Text of all public comment emails

Southwest Corridor Lightrail Scoping Comments
600 NE Grand Ave
Portland, OR 97232-2736

SW Corridor Planning— September 30, 2014

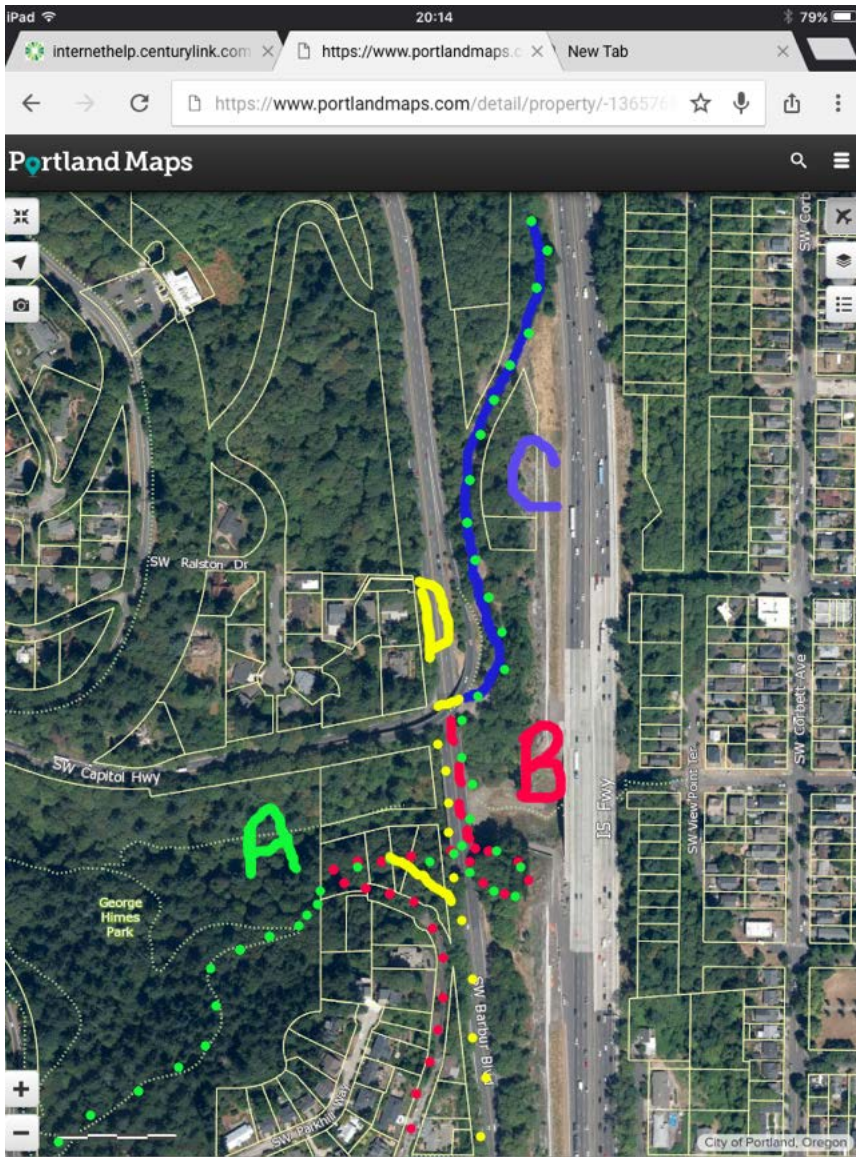
The Red Electric connections east of Hillsdale connecting to the Hooley Bridge are among the most important improvements affecting bicycle travel in SW Portland. Attached is a sketch of how this would be accomplished. The investment in this safer route on streets with low traffic may do nearly as much to reduce auto from Hillsdale and further west as use as the light rail itself for a large number of people who will bicycle if we provide a safe way for them to travel. The wide adoption of electric assist bicycles, especially in hilly SW, will enable a much larger segment of our population to utilize these safer routes. The attached aerial photo has been marked up to identify four key components of the connection and the plans for completing the Red Electric at this location, it includes a signal recently proposed by ODOT at the north end of the Newbury Bridge to make it safer for bicycles to cross the uphill moving traffic going to Hillsdale via Capitol Hwy.

A. The green dots show how the eastbound pedestrians using the trail in Himes Park extended from the switchback (shown in small white dots) to connect with the proposed bicycle linkage described in B below and continue under Barbur at the first bent (cavity) and thence via a loop up onto the Newbury Barbur Bridge (Viaduct) northbound on the east side of the bridge, and thence north along the rebuilt Slavin Road described in C below to connect to Corbett, the Hooley Pedestrian Bridge and get to the Willamette River and the many connections there.

B. The red dots and red dash lines shows the route of the bicycles coming from the west along SW Parkhill Drive to a new trail built to go west a short distance and then switch back and go under the first bent (span or cavity) of the Newbury Barbur Bridge and follow the same route north across the bridge, and then either follow the bicycle lanes on Barbur or follow Slavin Road to connect to Corbett, the Hooley Pedestrian Bridge and get to the Willamette River and the many connections there. The dash lines indicate the new bicycle lane on the Newbury Bridge to accommodate bicycles when the second southbound vehicle lane is removed.

C. The blue line of C indicates the renewal of Slavin Road, utilizing much of the existing street but rebuilding about 700 feet to accommodate bicycles and pedestrians but no vehicles.

D. The yellow dash across Barbur at Capitol Highway indicates a full on demand signalized intersection to allow southbound bicycles and pedestrians from Slavin Road to safely cross from the north end of Newbury Barbur so that they may continue south on the west side of Barbur. The dotted yellow marks indicate the bicycle lane created when the second southbound vehicle lane is removed. The signal would be used by bicycles coming south on Barbur as well as by the bicycles and pedestrians seeking to cross Barbur from Slavin Road. At the south end of the Newbury bridge, the yellow line leading west shows where pedestrians and bicycles would be able to connect to the ped and bike route leading from under the southmost span or cavity of the Newbury Structure and proceed up to Parkhill Drive. See the additional yellow line indicating this connection. (see attached photo with sketch)
